Inspection Report 2-4 Cunningham Street, Haymarket

City Investigation Officer Inspection and Recommendation Report
Clause 17(2), Part 8 of Schedule 5, of the Environmental Planning and Assessment
Act 1979 (the Act)

**Re: INSPECTION REPORT
ASPECT
2-4 CUNNINGHAM STREET HAYMARKET ("the premises")**

Figure 1

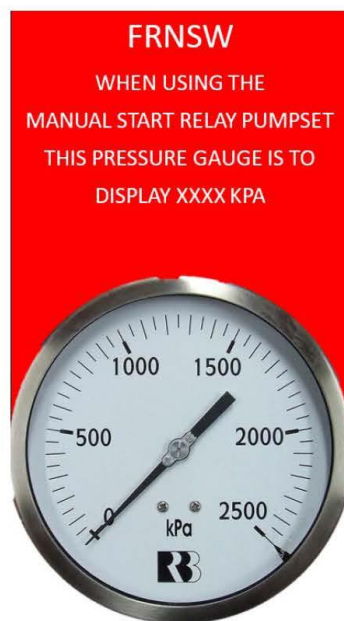
FRNSW position statement '[FRNSW pump performance for high rise buildings](#)' states, the fire hydrant system is to be designed for a 'Boost Pressure' of 950 kPa being input into the fire brigade booster connection from a standard FRNSW pumper, for buildings having an effective height greater than 50 m and requiring a fire brigade relay pump. FRNSW are of the opinion that the boost pressure signage should state, BOOST PRESSURE 950kPa and the relay pump be modified to ensure correct operational pressures.

Additional signage should be installed along with a 150mm pressure gauge similar to *Figure 1*, to advise firefighters of the required pressure at the RELAY PUMP discharge.

1A.C.	FRNSW are of the opinion that the boost pressure signage should state, BOOST PRESSURE 950kPa and the relay pump be modified to ensure correct operational	The current BOOST PRESSURE is 1150KPA and FRNSW have not indicated why this boost pressure is

Ref	Issue	City response
	pressures. Additional signage should be installed along with a 150mm pressure gauge to advise firefighters of the required pressure at the RELAY PUMP discharge. The manual start controls for the relay pump are also located within the Fire Control Room (FCR). It is recommended for additional relay pump manual start controls be installed at the fire brigade booster.	insufficient and why the relay pump should be modified. The current fire hydrant system was installed to AS 2419.1-1994. If the current boost pressure is acceptable under AS 2419.1-1994, then it is unreasonable to upgrade the relay pump. Relay pump manual start controls at the fire brigade booster are not required under the Building Code of Australia or Under Australian Standard 2419.1 and its unreasonable to install them while they are already present in the FCR. This will be further investigated under the Fire Safety Order issued on the owners on 27 April 2022, addressing this issue.
